A BRIEF SUMMARY OF AD 81-15-3

Due to the complex writing of this AD, we have had many calls for clarification. This letter is to try to briefly describe the AD.

PART I

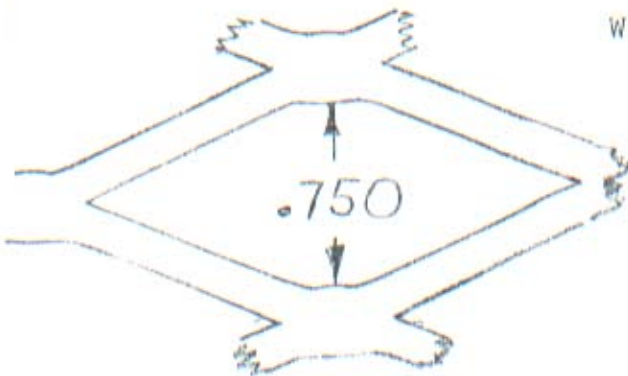
This part covers all the listed filter assemblies. This AD wants you to check and see if the filter frame has a welded in large aluminum diamond retainer. If it has the large diamond, then it must be replaced with the proper steel screen. Most of these were corrected under the previous AD 78-25-05. All filters manufactured after September, 1978 have the new screen.

The above is affected by
AD 81-15-3.

None of the above are affected.
